Proposed Residential Development, Ardshanavooly,
Killarney, Co. Kerry

Stage 1 Road Safety Audit

July 2026

Figure 2.1

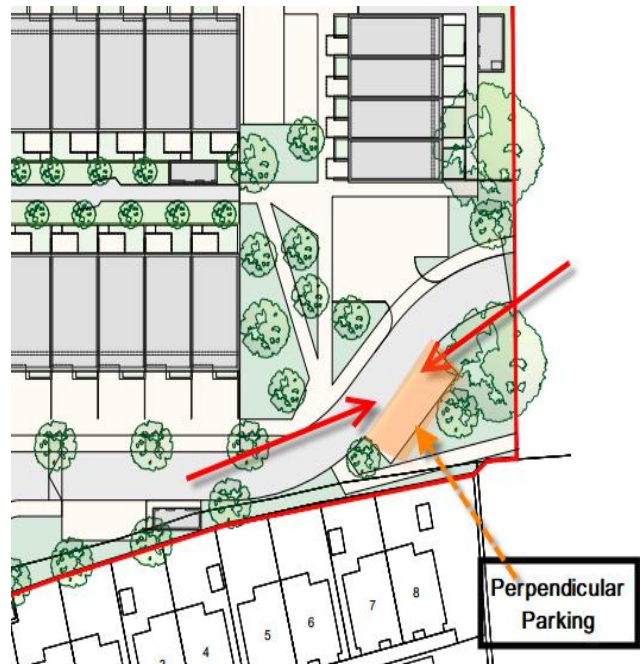
2.1. Problem: Connectivity to the development Lands to the east.

The site layout has made provision to show both a pedestrian and vehicle connection to the future development lands to the east at the south west corner. The design appear to show perpendicular parking along this section of the site on approach/receding from the horizontal road curve. The design guidelines including the forward visibility as set out in the Design Manual for Urban Road & Streets (DMURS) should be provided at this location and internally within the development. Inadequate forward visibility to these parking spaces may lead to collisions between vehicles passing by on estate road and vehicles exiting the parking spots. Refer to Fig 2.1

A parking arrangement with an adequate forward visibility envelope is required, in accordance with the relevant standards for the road design speed. The visibility envelope should be kept clear of all obstructions such as wall, hedges, fences, signs etc and vegetation over 600mm in height.

2.1	Y	Y	Layout revised to provide parallel parking in this location to overcome perpendicular parking sightlines issue. Drawing reference 10029 Ardshanavooly - 1003 - 02 - Site Layout Plan
